**Planning Commission
Regular Meeting Agenda
Wednesday, November 2, 2022 at 7:00 p.m.**

**City of Lowell, Oregon
Minutes of the Planning Commission Meeting
September 7, 2022**

**Revised Staff Report
Site Plan Review Application
Mixed-Use Development on North Shore LU 2022 02 (Phase 1)
October 26, 2022**

Image 6. Applicant's proposal to make the existing fence sight-obscuring. Image provided by applicant's architect.

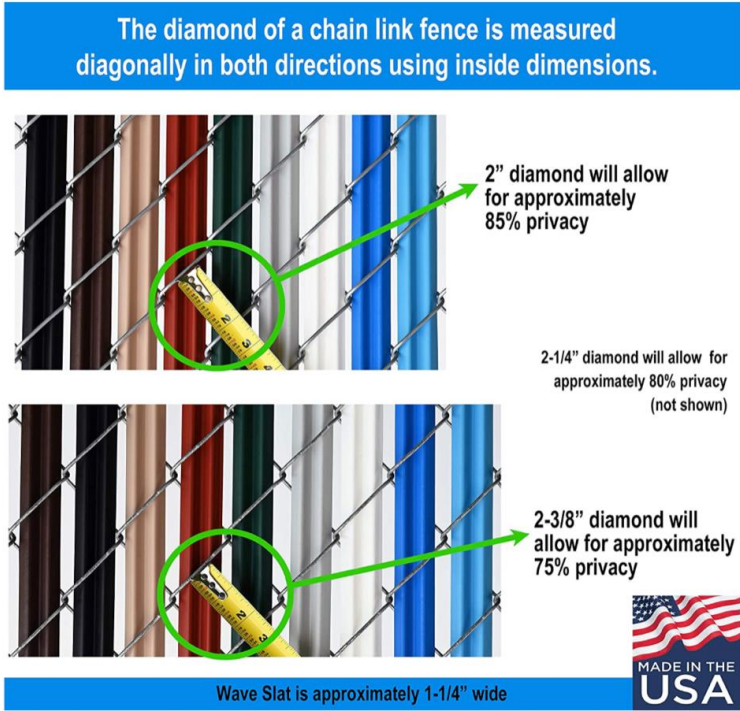
Recommended FINDING for approval: There is an existing fence along the rear of the property. The applicant is proposing to add wave slates to make the fence sight-obscuring. A fence that is sight-obscuring is an acceptable method to screen objectionable uses and mitigate nuisances between the mixed-use development and the existing residential uses in the vicinity.

Condition of Approval #11: Prior to the issuance of certificates of occupancy, the fence along the rear of the property line shall be made to be at least 75% opaque as proposed by the applicant.

1 AS-003 Architectural Site Plan
SCALE: 1" = 30'

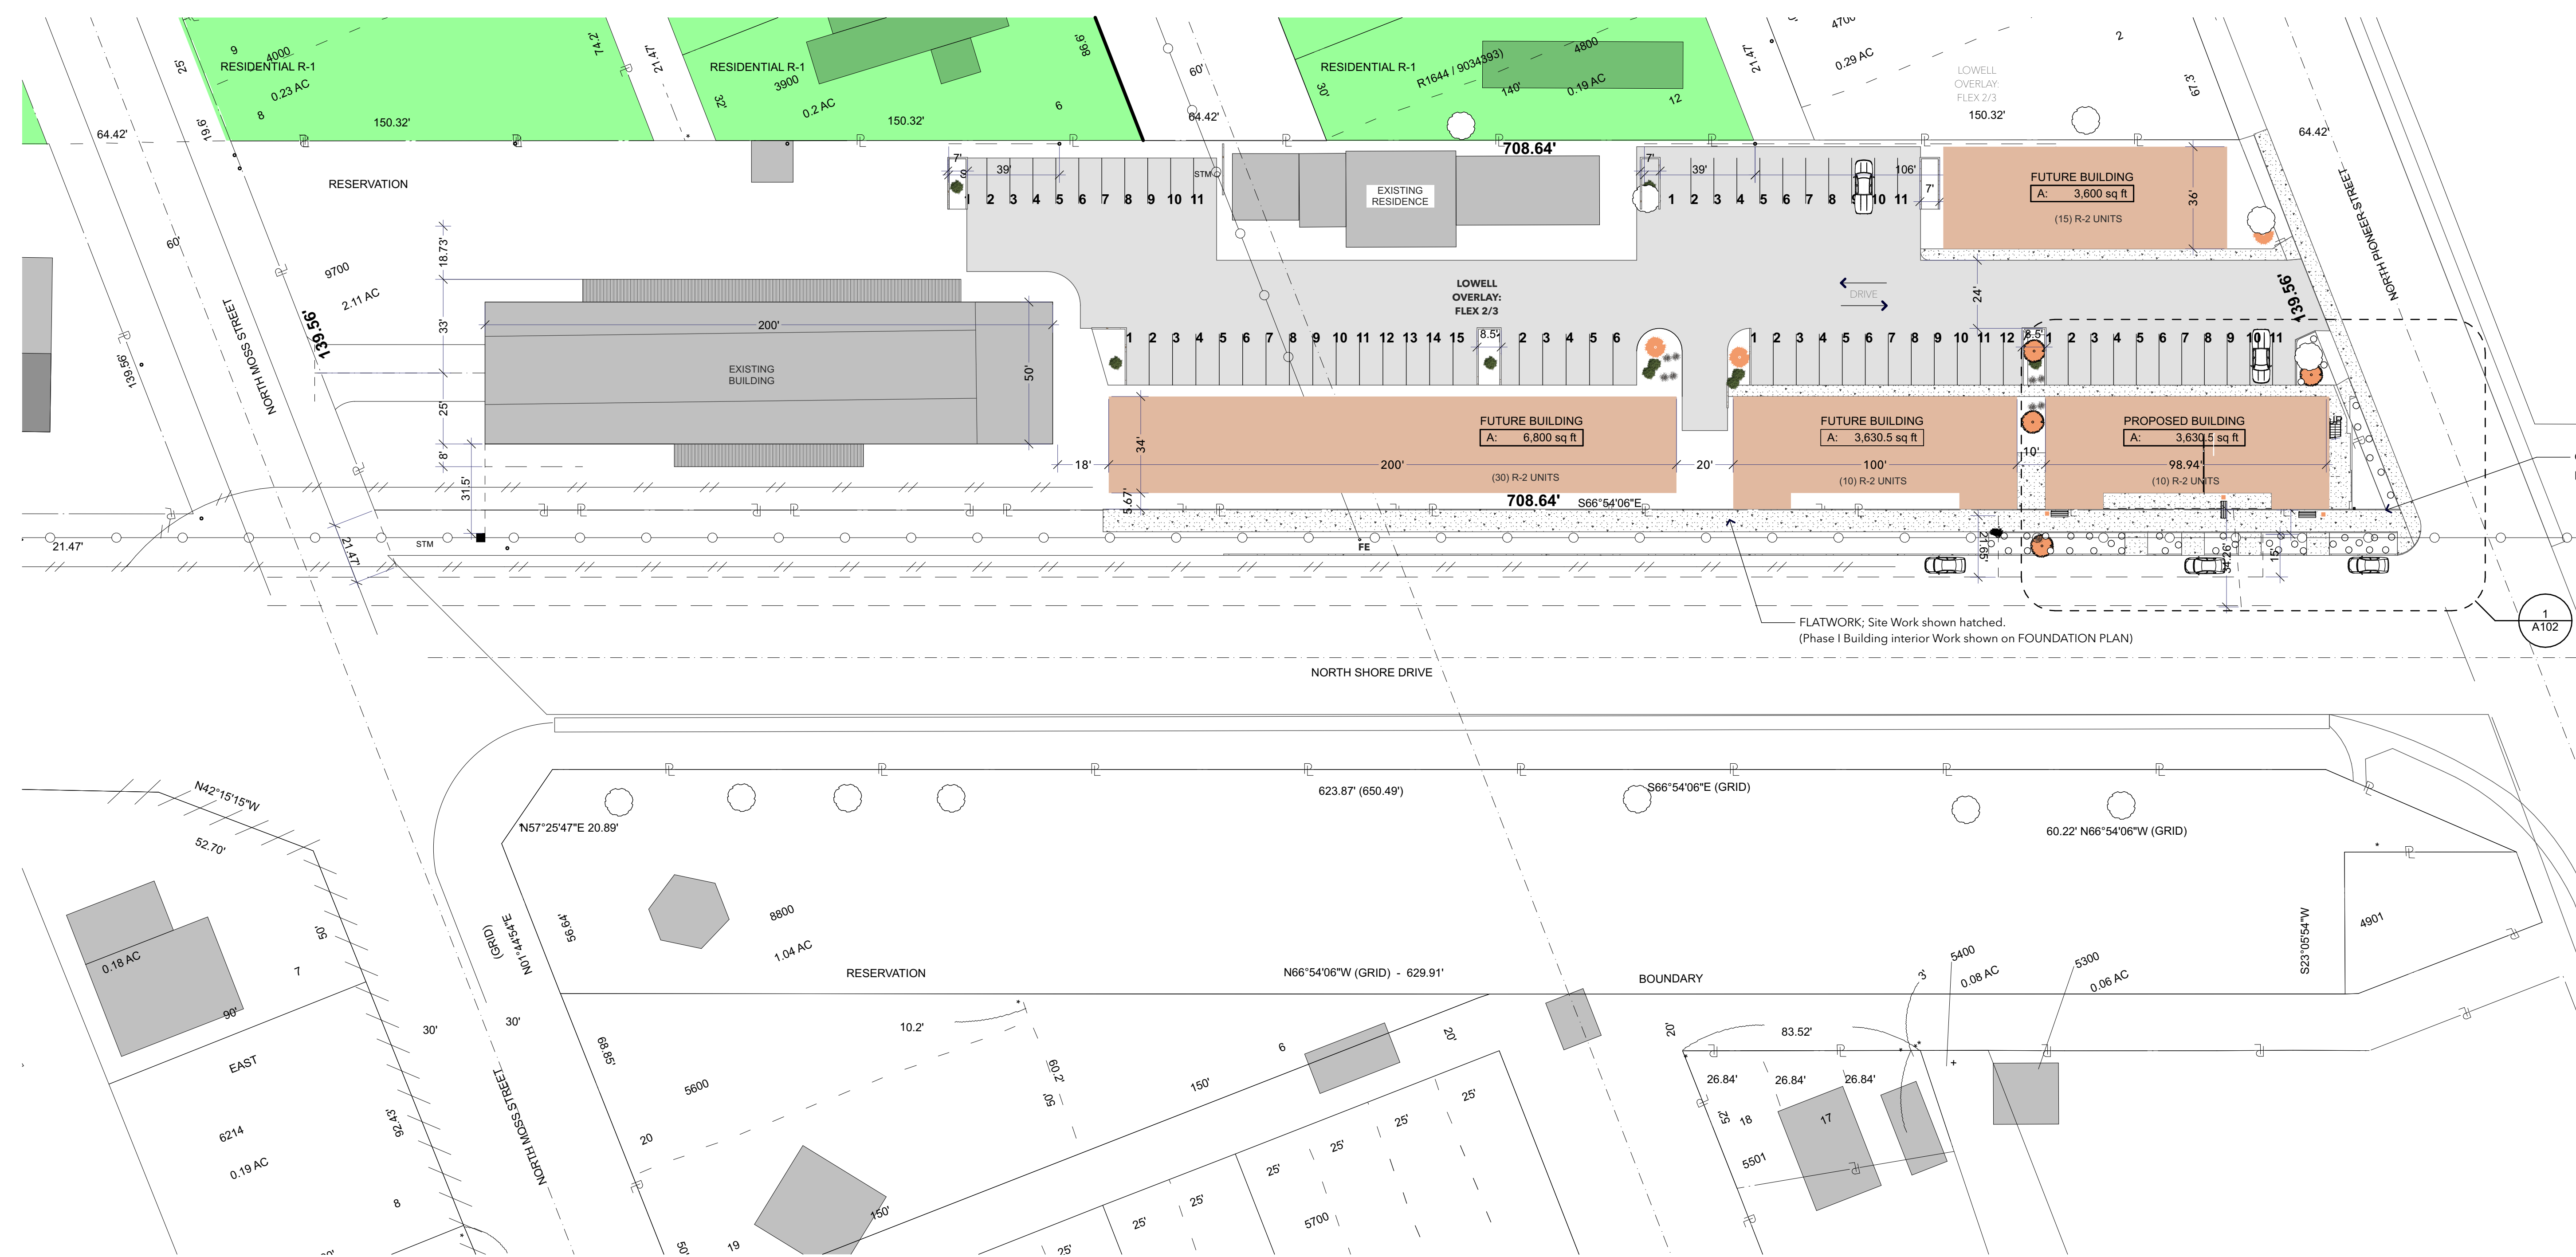
Recommended FINDING for approval: Presently, the site is vacant and is not connected to City services. The applicant will tap into and extend the existing water and sewer mains located behind the property in First Street. See Sheet AS-003 for connection points. The applicant has submitted a basic site plan that shows an existing storm sewer tie in located in First Street where the applicant is proposing to tie into new water and sanitary sewer connections. A possible storm water tie in is shown on the site plan, with on the tie in leading out towards the right-of-way on North Shore Drive. Proposed catch basin locations have also been noted on the site plan.

Based on the site plan submitted (AS-003), and the Public Works Director’s comments contained in **Attachment G**, staff find it feasible that proposed utility connections are available. Staff recommend a condition of approval for the final site plan/construction plans to show adequacy of the waterline connection. This issue has been raised by the City Engineer in email comments

Recommended FINDING for approval: As seen on Sheet AS-003, the entrances along the frontage of North Shore Drive will have covered entries. The proposal is consistent with this policy.

Recommended FINDING for approval: As seen on Sheet AS-003, the applicant is proposing a recycling enclosure at the far western side of Phase 1 see "recycle enclosure" on site plan. The plans do not show how the recycling enclosure will be screened from public view and landscaped. This will be a condition of approval.

- Sheet AS-003 indicates there is an existing residence located along the rear property line. What is to become of this residence? And it is really a residence? This residence has no address assigned to it.

Condition of Approval #3: Prior to the issuance of building permits, the applicant shall submit engineering plans for the extension and construction of water and sewer lines to the City Engineer and Public Works for review and approval.

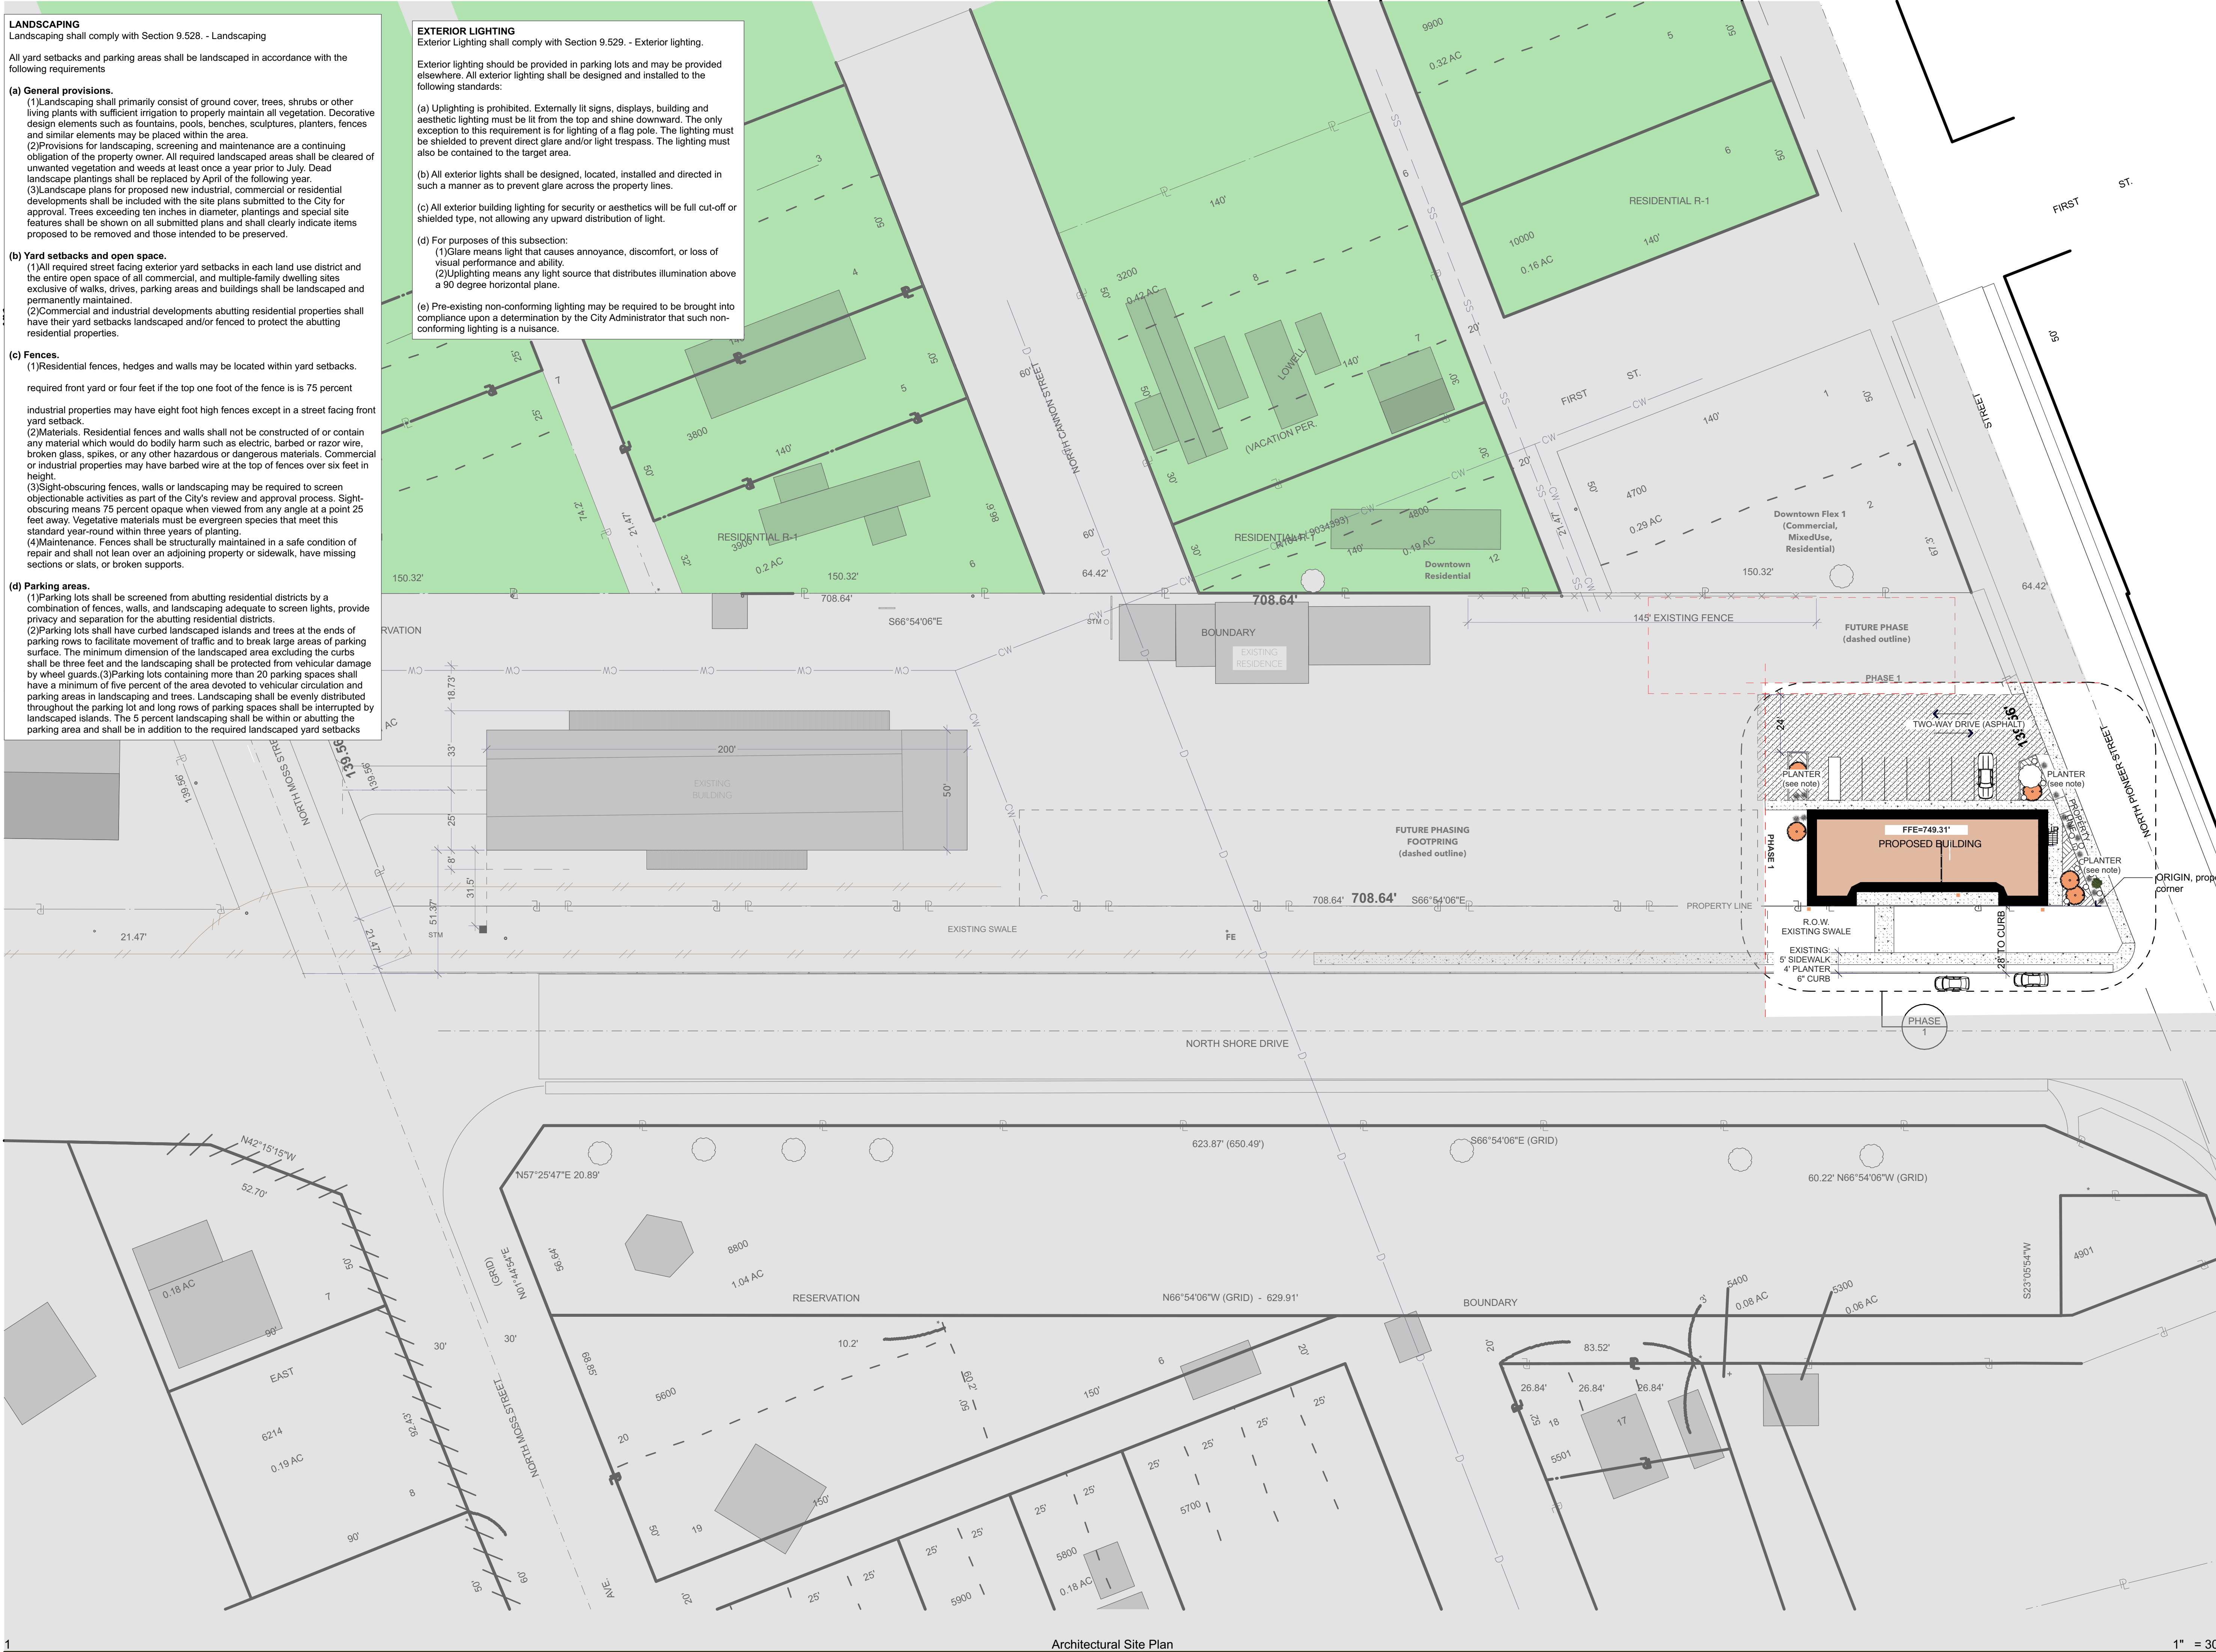
Recommended FINDING for approval: The applicant has addressed the feasibility of exterior lighting on Sheet AS-001, dated 10/20/2022. The applicant has included the exterior lighting standards on Sheet AS-001. Staff find this is sufficient to address feasibility so that a final exterior lighting plan can be delegated to the City Administrator for final review and approval. The applicant will be required to submit a final exterior lighting plan in accordance with Section 9.529 as a condition of approval. The final exterior lighting plan shall address and contain all of the elements and criteria as listed in Section 9.529. The exterior lighting plan shall be reviewed and approved, prior to the issuance of building permits. All exterior lighting shall be in-place and operative before the issuance of certificates of occupancy. This will be a condition of approval.
